Application of Nationwide Investments, LLC to rezone from R-75 (Residential Medium Lot-75) to MR-1 (Medium Density Residential-1), to allow construction of a single-family detached and single-family attached (townhome) development.

PETITION NO: N12. Z-22-1245580 (2022-1480)

LOCATION: 496 Warren Avenue, Scottdale, Georgia 30079

STAFF ANALYSIS

SITE PLAN

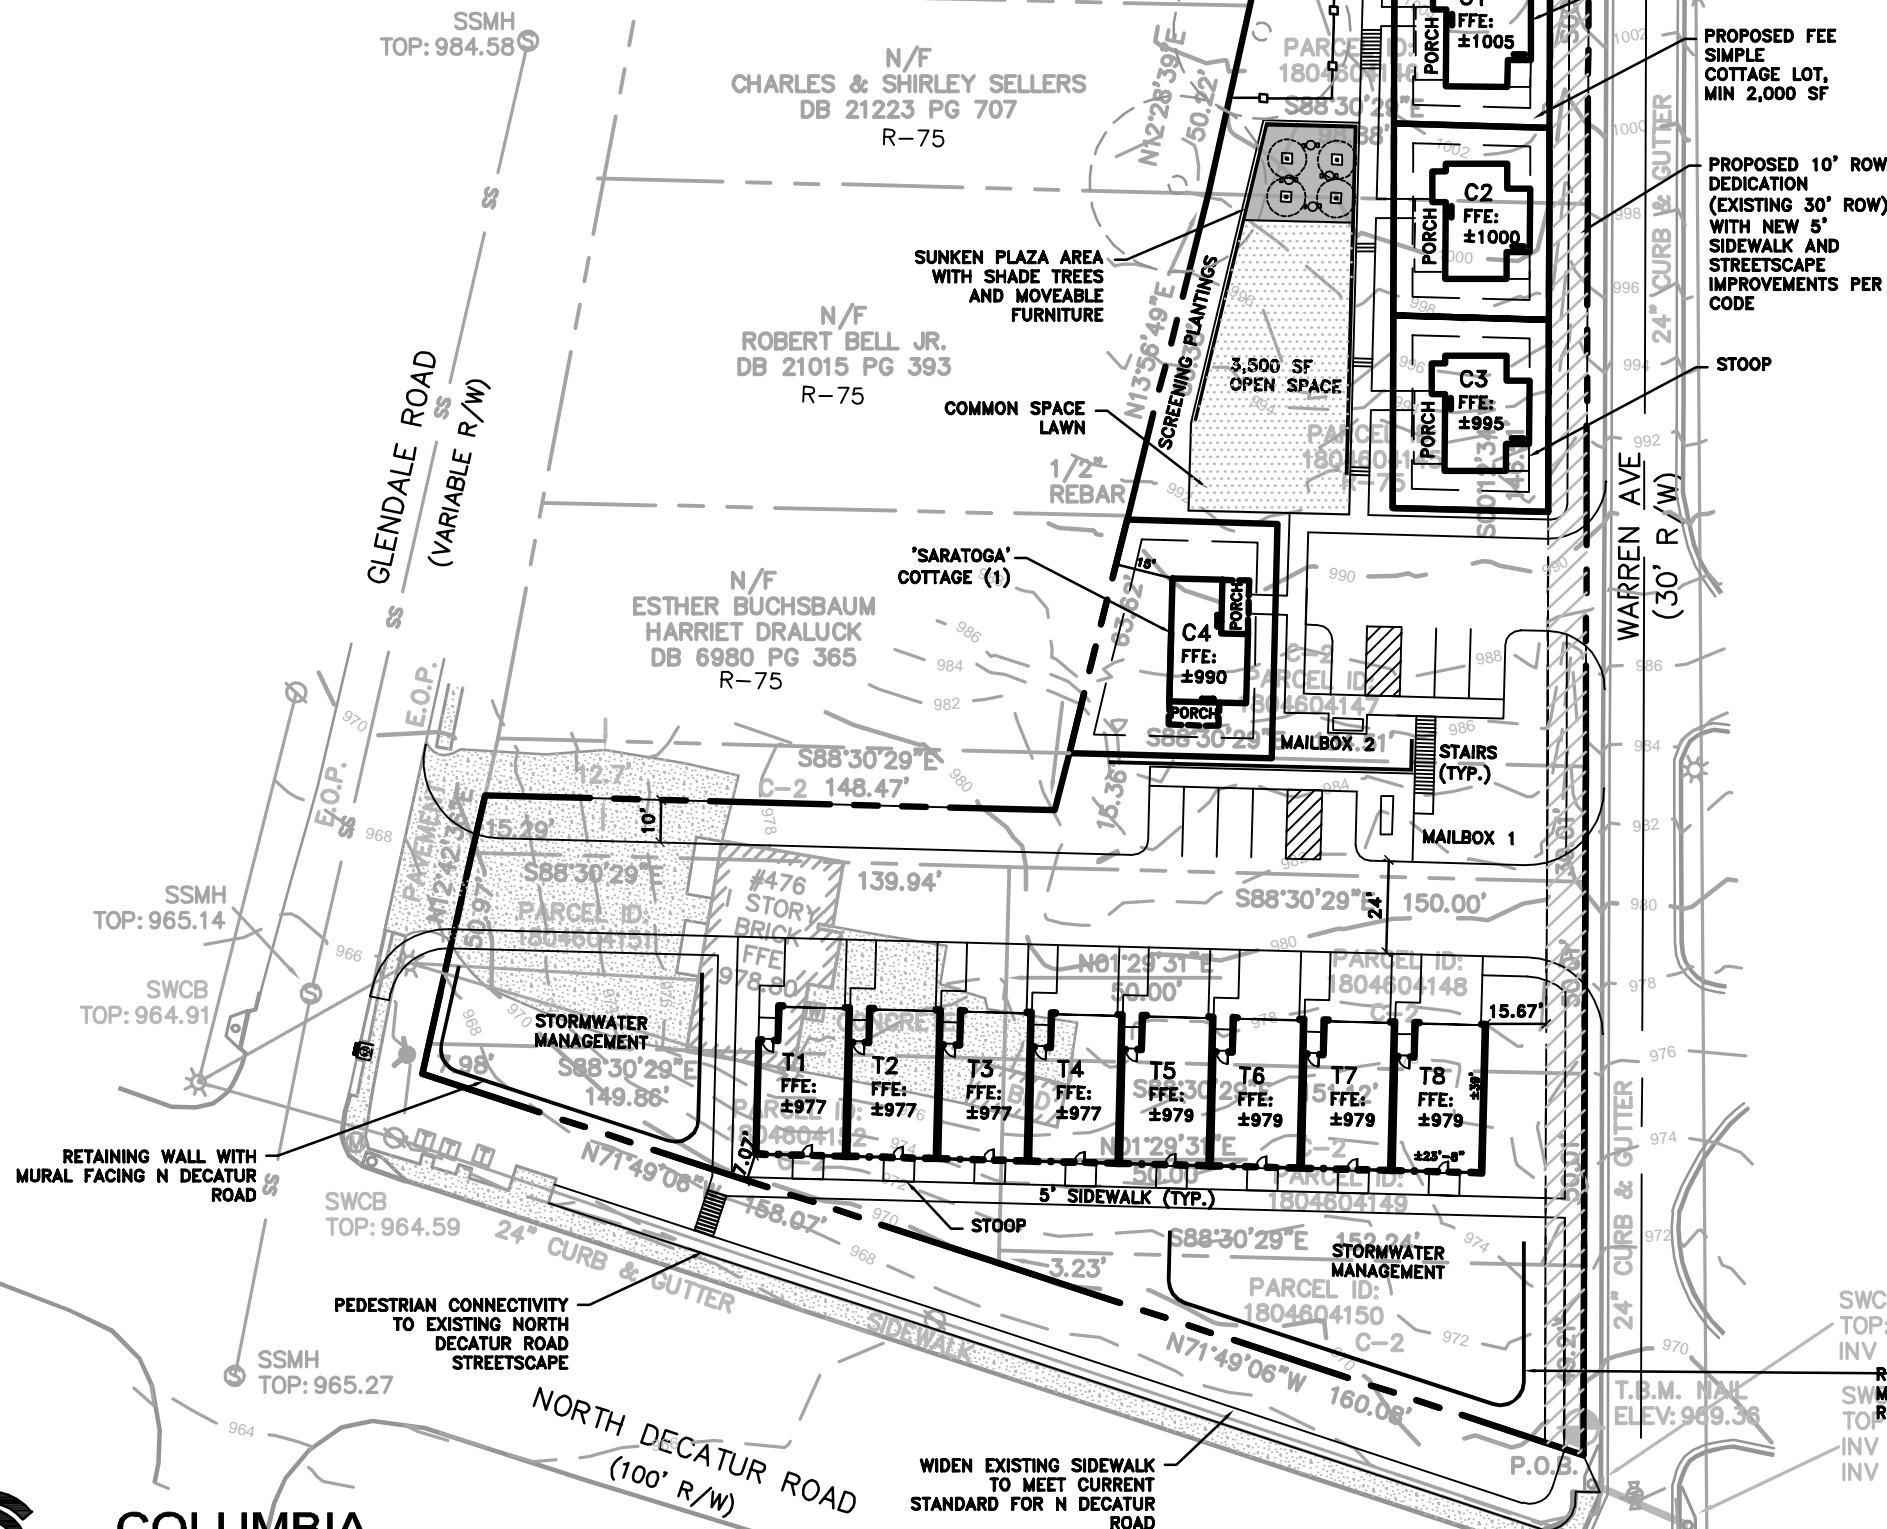
The community has expressed concern regarding the setback between the western most cottage and the western boundary of the development, in response the applicant has proposed to increase this set back from 5-feet to 15-feet.

- a. The **Transportation Division** submitted comments regarding the required right of way dedication and streetscape design, which may impact final lot size, design and/or setback. In addition, they have stated:
 - i. Developer needs to watch access management requirements in Land Development Code Section 14-200 (6) for the required distance between access point on Glendale Road and North Decatur Road. Access point on Glendale Road needs approval from Transportation Division in Land Development Permitting- may be restricted to right-in right out due to proximity to traffic signal.

- b. The **Storm Water Management Division** commented there are concerns about how close the storm water detention ponds are to the roadway:
 - i. There are concerns related to the discharge point of the stormwater facility. Proximity of the stormwater facility to the street suggest that facility will discharge towards the street. No concentrated flow shall exit the site. Runoff Reduction Volume shall be provided, unless technical justification is provided as to the unfeasibility. Strongly recommend to investigate the site and identify location where RRv can be provided and re-design/revise the layout to comply with the RRv requirement.

There are concerns related to the discharge point of the stormwater facility. Proximity of the stormwater facility to the street suggest that facility will discharge towards the street. No concentrated flow shall exit the site. Runoff Reduction Volume shall be provided, unless technical justification is provided as to the unfeasibility. Strongly recommend to investigate the site and identify location where RRv can be provided and re-design/revise the layout to comply with the RRv requirement.

4. There shall be substantial compliance with the proposed locations of cottage and attached homes shown on the site plan “Scottdale Cottages and Townhomes” dated 02/23/22.

5. The two retention ponds along North Decatur Road must be visually enhanced by at minimum:
 - a. Installing a black metal fence and planting at least two types of vegetation; OR

- b. Installing retaining walls with a decorative surface to include a mural, or other aesthetic design.
6. Prior to land development permit approval, the developer must declare which amenities (seating, outdoor furniture, walkways, water features, etc) will be provided within the cottage development open space area and provide the requisite plan details. These amenities must be installed prior to the issuance of a certificate of occupancy for the first residential unit.
